PCN Number: 1604-3
Chgnot.doc rev. __ 4/16

Product/Process Change Notification (PCN)

Summary description of change: Part Change:

Legacy UA

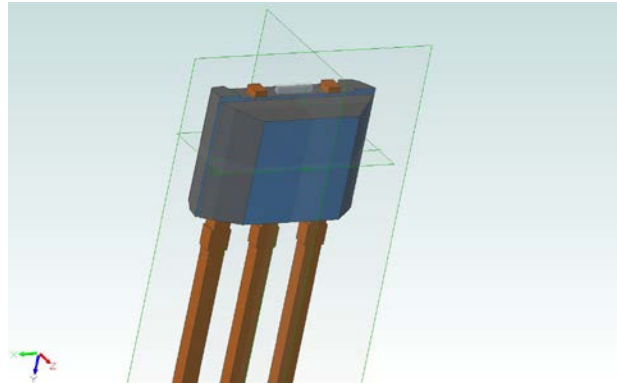
Legacy UA vs Matrix HD UA - Visual Differences

Matrix HD UA

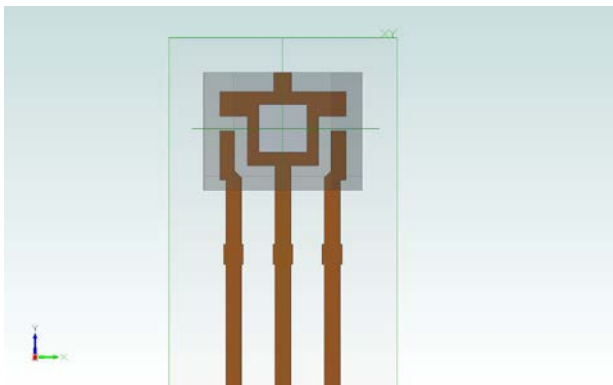
- Top of package on the Matrix HD UA has tie and dam bar protrusions

Legacy UA leadframe

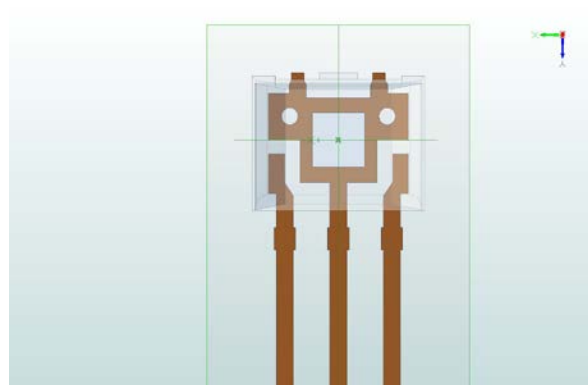
Legacy UA vs Matrix HD UA – Leadframe Differences

Legacy UA

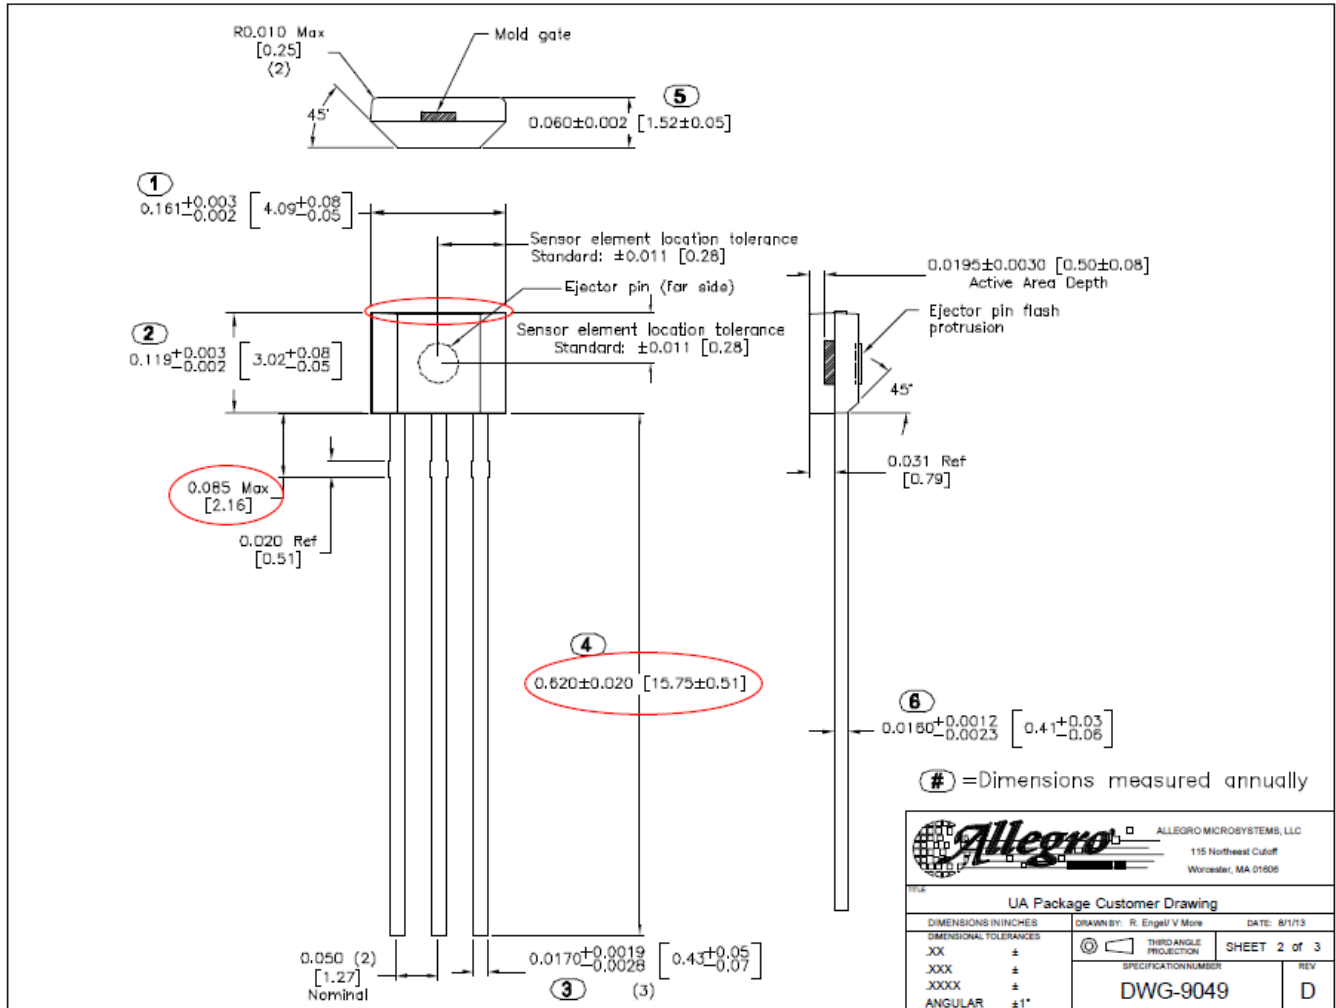
Package lead length: 15.75 +/- 0.51 mm

Legacy UA vs Matrix HD UA – Dimensional Comparison

Matrix HD UA

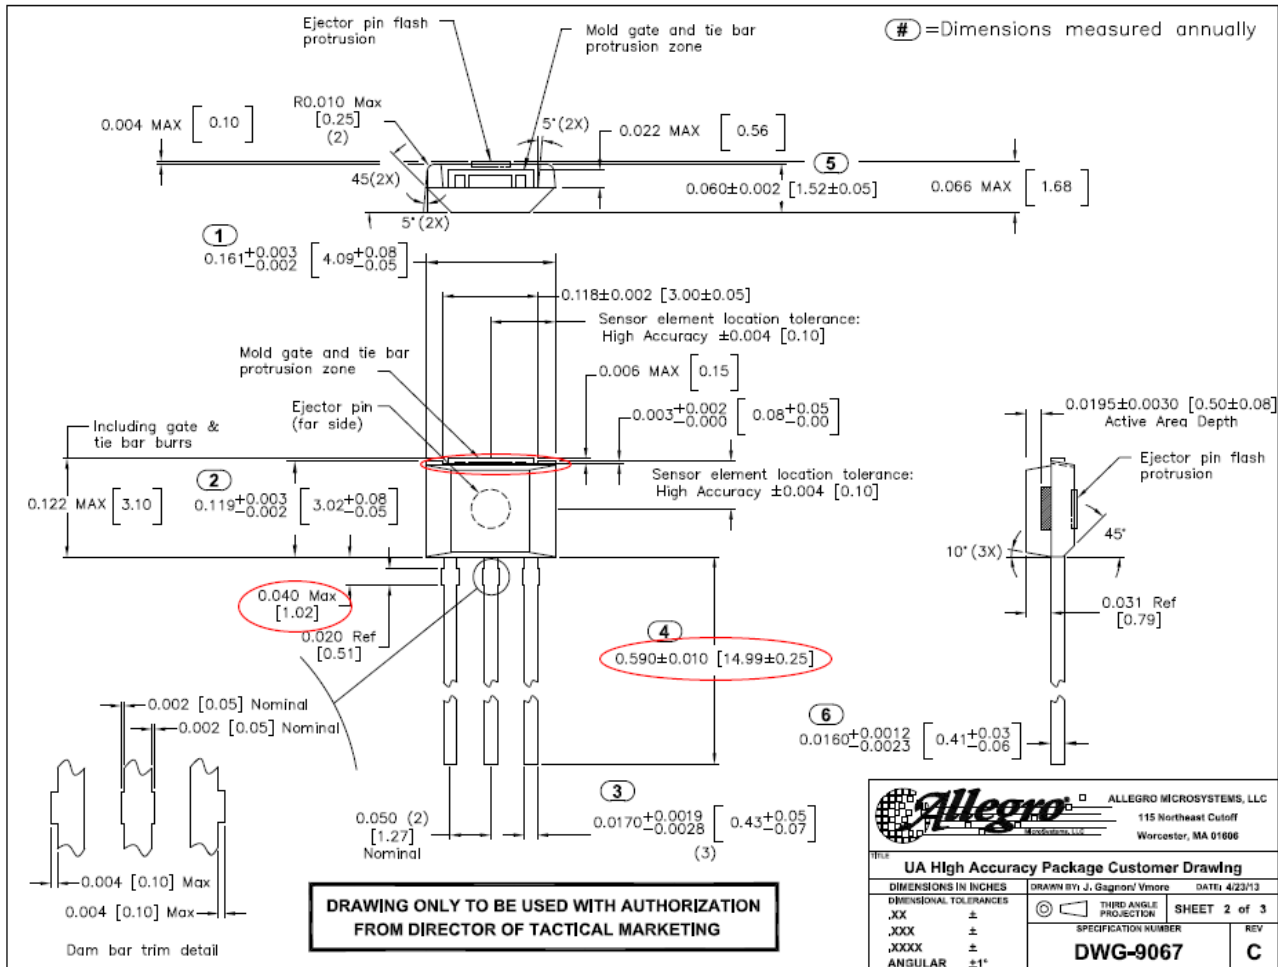
Package lead length: 14.99 +/- 0.25 mm

Legacy UA vs Matrix HD UA – Dimensional Comparison Continued

Package	Width (mm)	Height (including tie & gate bar protrusions) (mm)	Lead Length (mm)	Leadframe Mold Offset (mm)
Legacy UA	4.09 (+0.08, -0.05)	3.02 (+0.08, -0.05)	15.75 +/-0.51	+/-0.101
Matrix HD UA	4.09 (+0.08, -0.05)	3.02 (+0.08, -0.05)	14.99 +/-0.25	+/-0.051
